Please see below and attached City of Seattle Public Review Comments regarding the Block 38 West - (15008) cleanup site.

From: [Encelle, Ophélie](#)
To: [Seeds, Tena \(ECY\)](#)
Cc: [Shivjiani, Dhroov \(ECY\)](#); [Macik, Jill](#); [Chesick, Katherine](#)
Subject: Block 38 West Comments/City of Seattle
Date: Tuesday, December 16, 2025 1:50:02 PM
Attachments: [City of Seattle Comments Figures FinalCAP Block38W.pdf](#)

FIGURE 3
 SITE PLAN WITH SAMPLE LOCATIONS
 BLOCK 38 WEST SITE
 SEATTLE, WASHINGTON

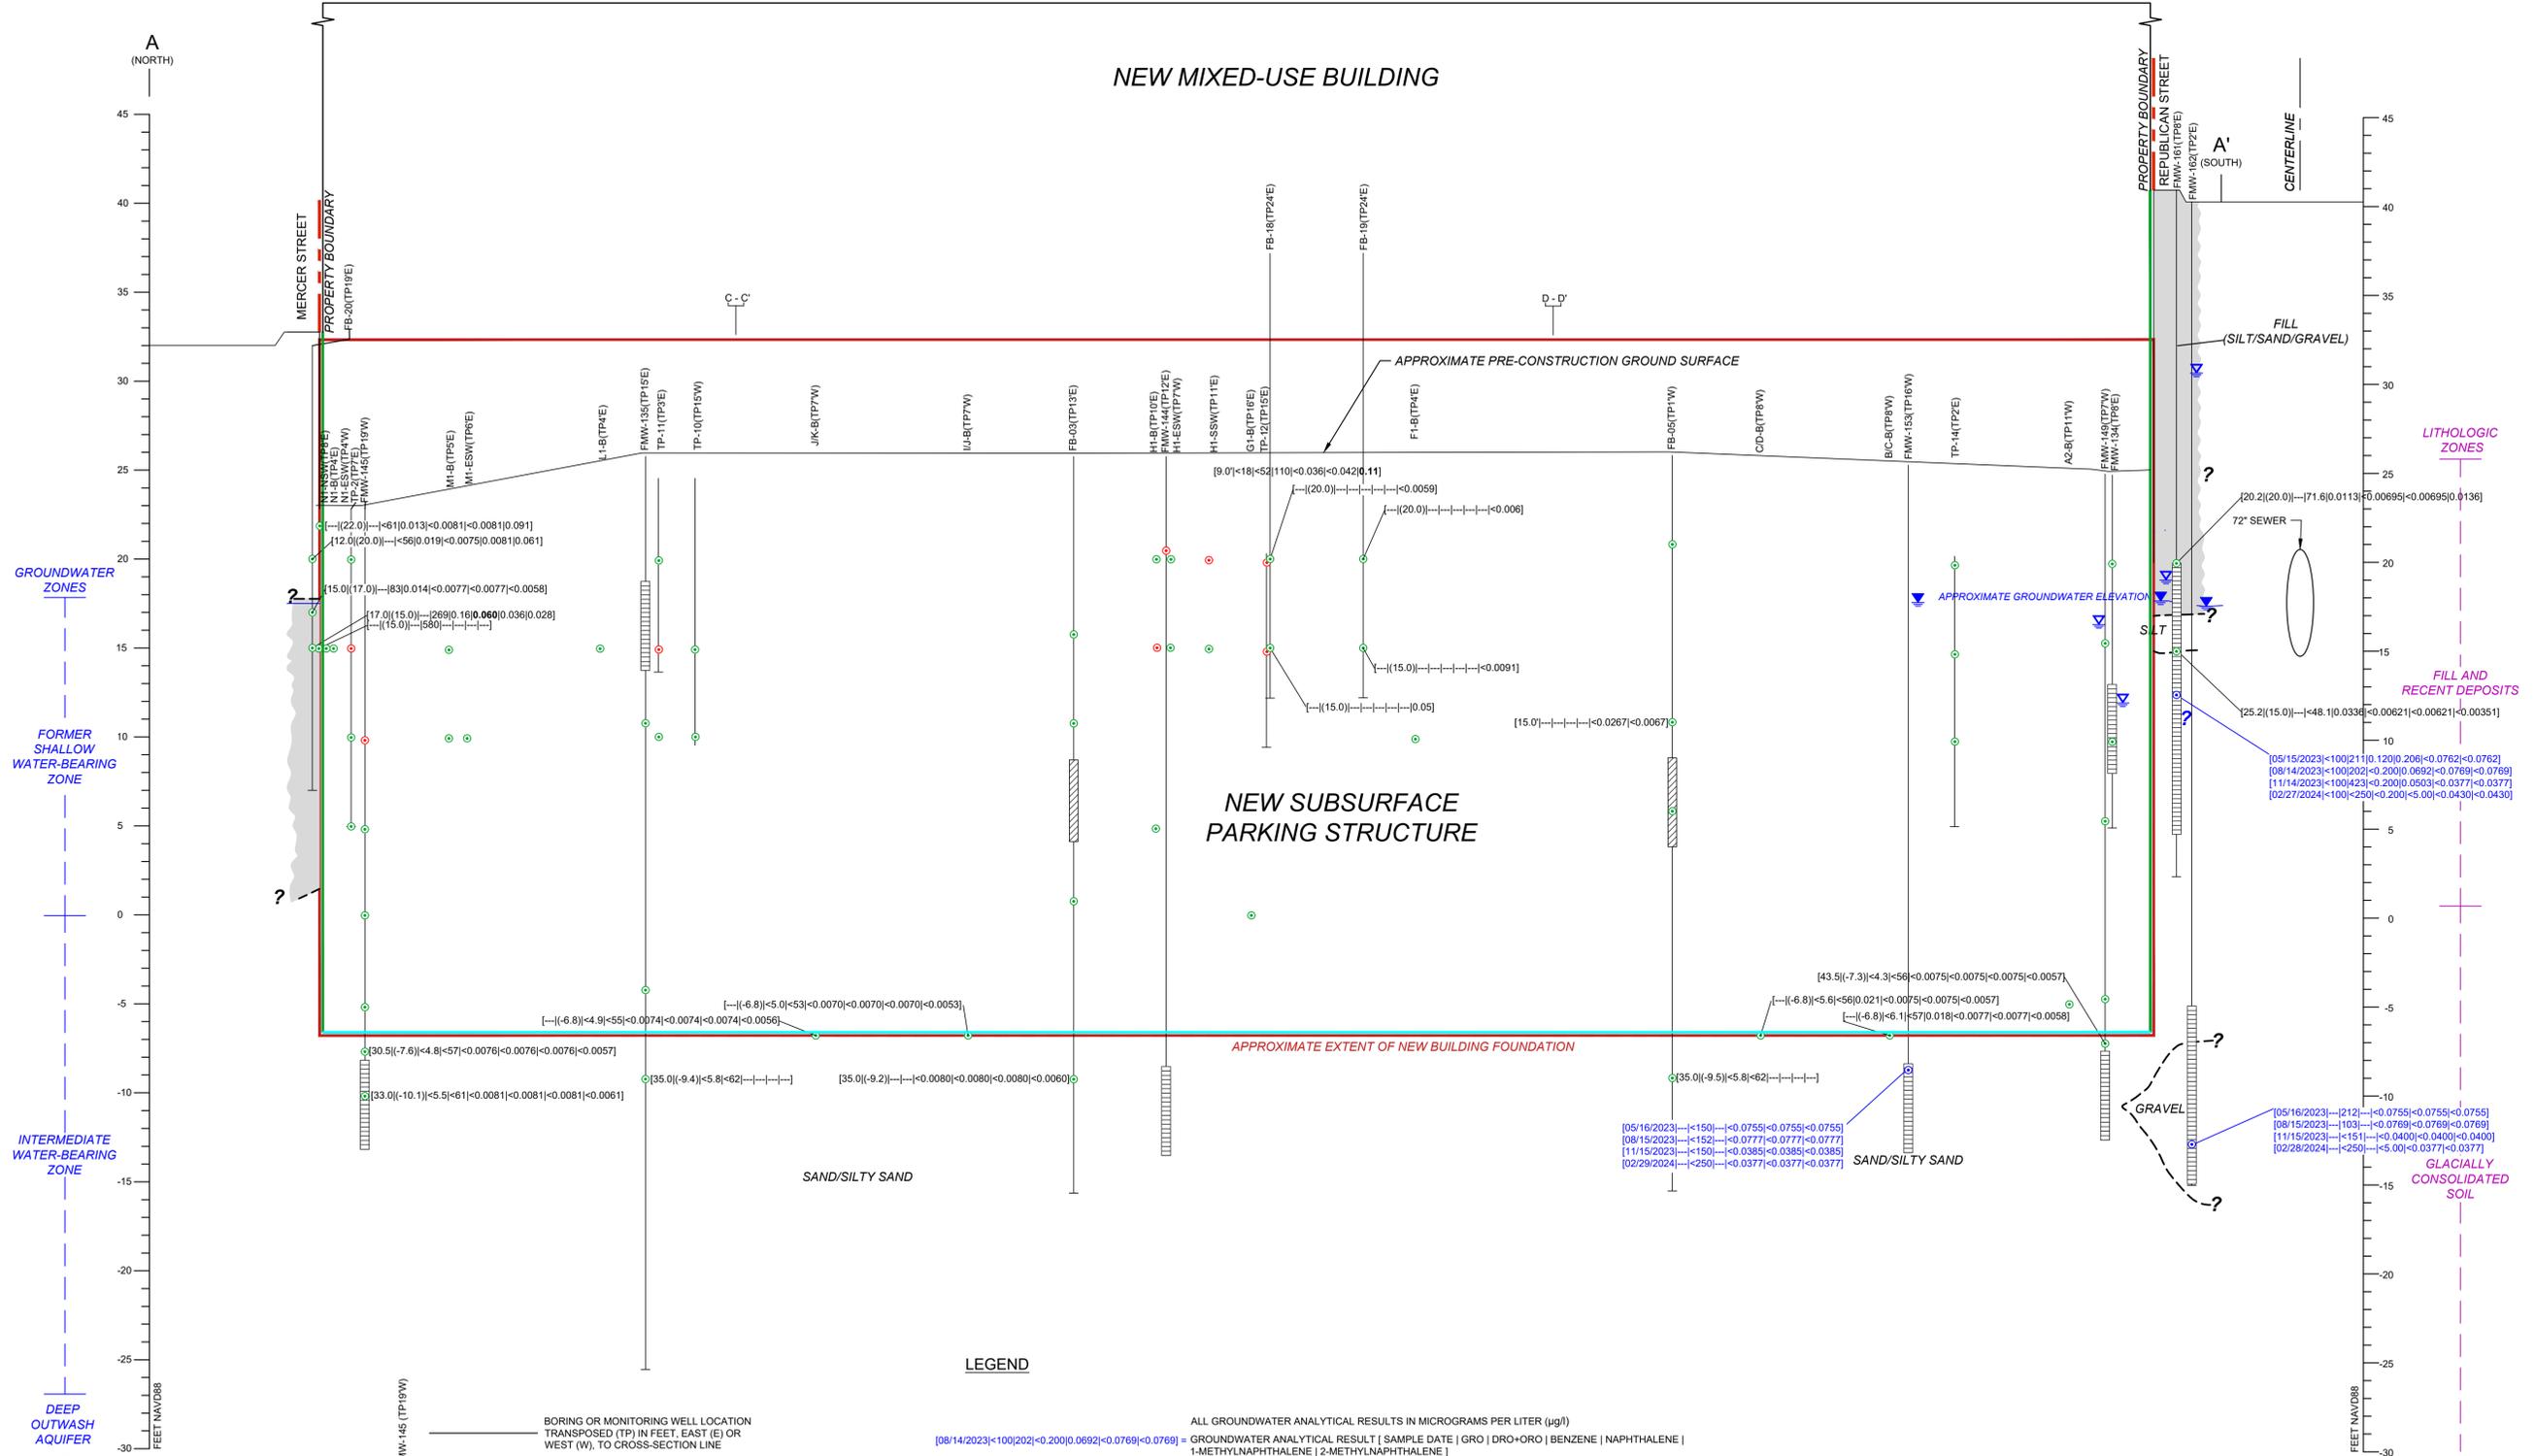
According to the site history, there are two USTs (UST02-B2 and a 1500-gallon heating oil UST) impacting the right-of-way however it is unclear to City of Seattle what the extent of this contamination is (see our comments on Figures 3, 6, 7 and 8). Additionally, it is unclear if the 1500-gallon heating oil UST has been removed and the surrounding soil cleaned up to current MTCA cleanup standard (see our comments on Figures 6, 7 and 8).

Is it possible to have a cross-section showing the CDF and contamination extent in the Westlake Avenue North ROW?

FIGURE 10

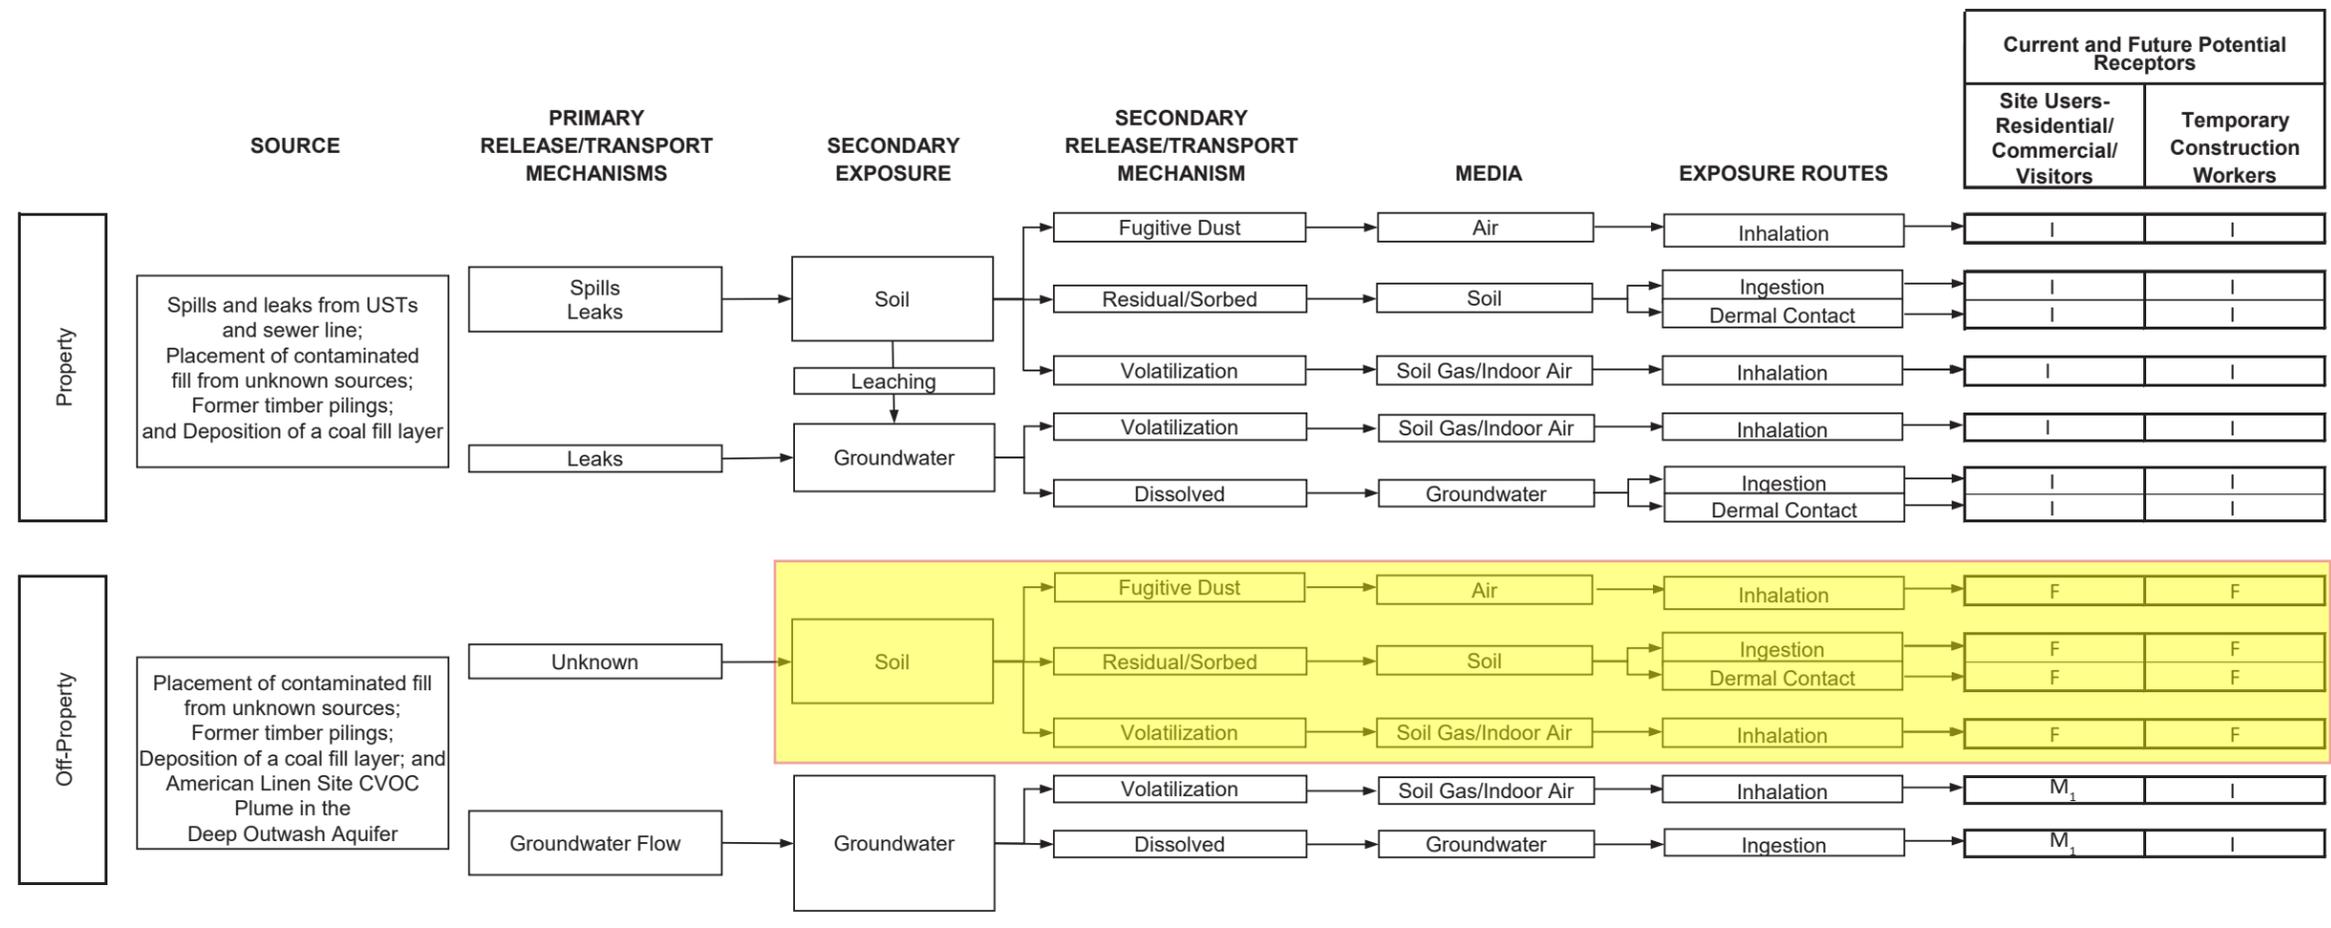
According to the CAP, the selected cleanup action will meet action-specific requirements applicable under WAC 173 340-360(3)(b) to allow for use of institutional controls, provide financial assurances, and allow for periodic reviews of annual cap inspections. We do not see proposed solutions to contain and eliminate the potential direct contact exposure pathway for the COCs remaining in soil for utility workers (see our comment on Figure 10).

How is this pathway addressed?
